## REVISED RESPONSE TO REQUEST FOR ADDITIONAL INFORMATION

### APR1400 Design Certification

Docket No. 52-046

RAI No.: 227-8274  
SRP Section: 03.08.04 – Other Seismic Category I Structures  
Application Section: SRP 3.8.4  
Date of RAI Issue: 09/25/2015

Figure 1 Static Lateral Pressure

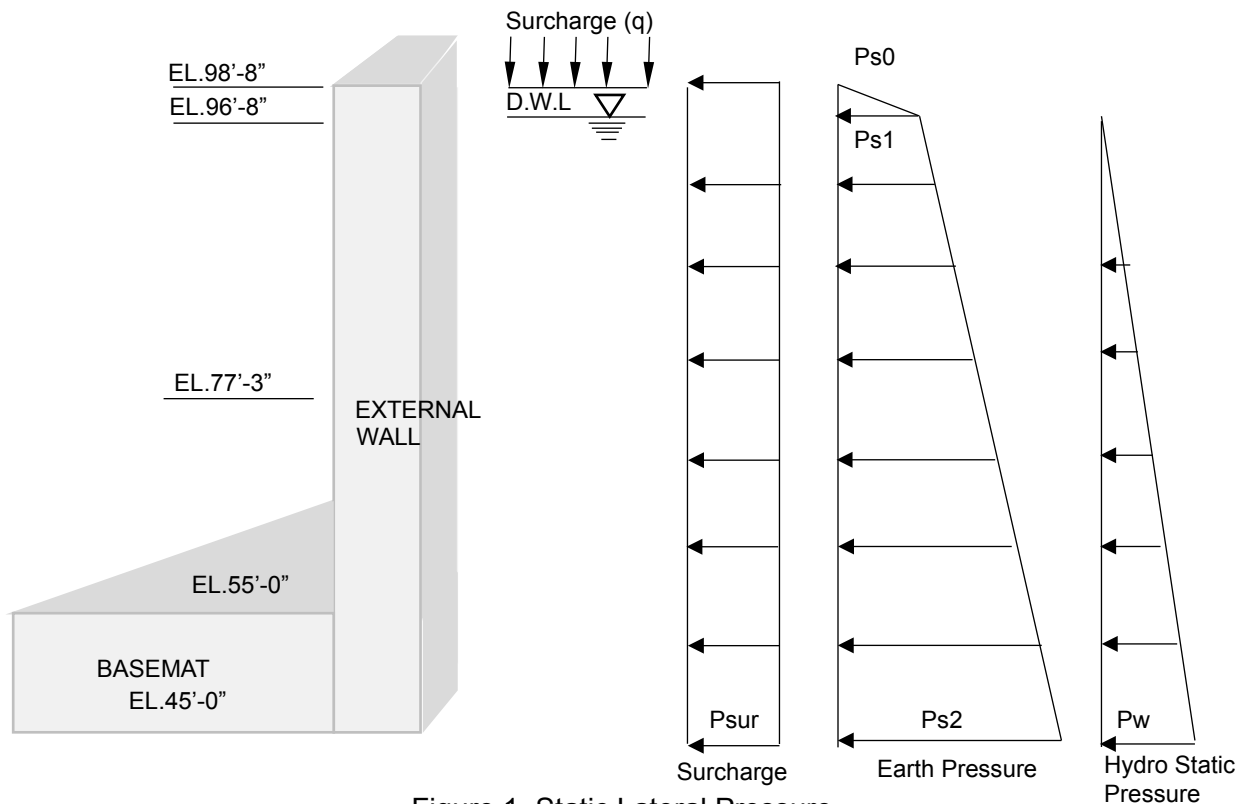
Applicant is requested to describe how the various water/flood related loads are classified (e.g., normal, severe environmental, abnormal, etc.), how they are calculated in terms of the loads used in DCD Section 3.8.4, how are they applied in the design of seismic Category I structures,

and whether there is sufficient design margin(s) in the loading combinations to accommodate the potential flooding loads of site-specific internal and external flooding sources.

Hydrostatic loads are calculated as a linearly distributed pressure on external walls depending on the design water level (EL. 96'-8") according to the basic equation of hydrostatics as shown in Figure 1. [The design groundwater elevation for the APR1400 standard plant design is based on the EPRI ALWR URD \(Utility Requirement Document\) Table 1.2-6 "Envelope of ALWR Plant Site Design Parameter". Therefore, the maximum design ground water level is determined to be 0.61m \(2 feet\) below the plant grade in the vicinity of the SSSc important to safety. Please see the applicant's response to RAI 75-8023 Question No. 03.04.02-1 item a.\(ii\).](#)
